**Re: Cañon Dolomite Quarry, File No. M-1977-376,
Preliminary Adequacy Review for Technical Revision No. 2 (TR-02)**

The following comments are based on the Division's review of the Request for Technical Revision TR-02:

1. Exhibit C-1, Pre-Mining Plan:

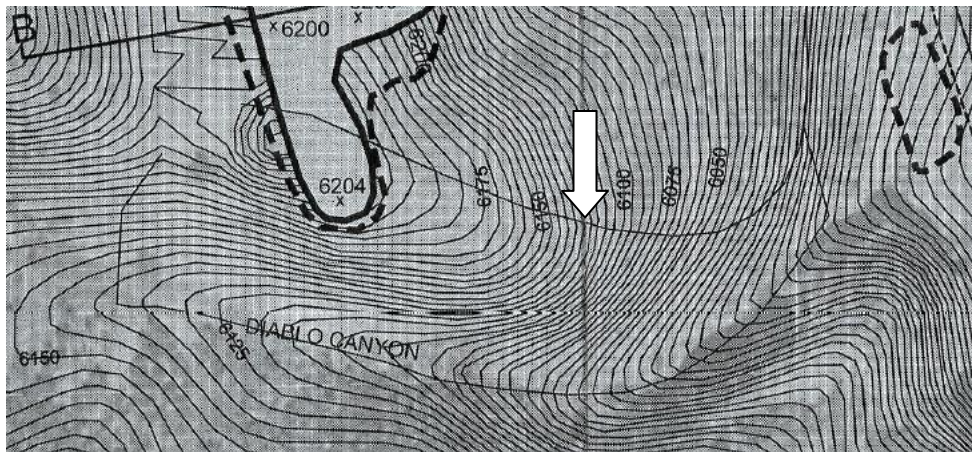
- a. The bar scales are not plotting correctly on the Key Map and Details 1, 2, and 3. The key map scale bar is roughly 1" = 2,100 ft, and the detail scale bars are approximately 1" = 210 ft. This is also the case for Exhibits C-2 and F. Please correct the scale bars.
- b. Note 2 indicates all disturbed areas outside the "Reclamation Liability Dashed Line Are Pre-Law Disturbances and Do Not Required Reclamation". Upon comparing Exhibit C-1 with Exhibits C-2 and F, there are areas east of the present mine disturbance in Detail 2, Mine Area; and Detail 3, Old Quarry Fines Disposal Area that are not included within a "Limit of Reclamation Liability" dashed line. Please reconcile or explain this apparent discrepancy.

Diablo Canyon line

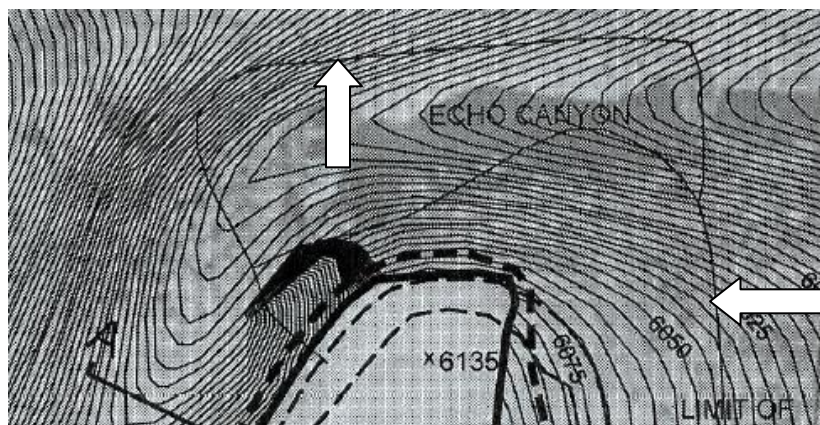
- c. Notes 3, 4 and 6 tally reclamation liability areas in the mine area (16.1 acres), “fill” area (2.2 acres) which do not match the mined area (36 acres) and affected area (55 acres) stated in Note 6. Further, the mine is permitted for 481 acres of disturbance.
 - i. Please explain the apparent discrepancy and provide a detailed tally for the purpose of estimating an appropriate financial warranty estimate
 - ii. Please clarify if “fill” in Note 4 should be “fines”.
- d. Note 8, Legal says Section 39, please correct the Section number.
- e. There are some fine lines on the drawing enclosing portions of Diablo Canyon and Echo Canyon, and a similar weight line connecting those enclosed areas running along the east side of the mine area (see below). Please identify these lines.
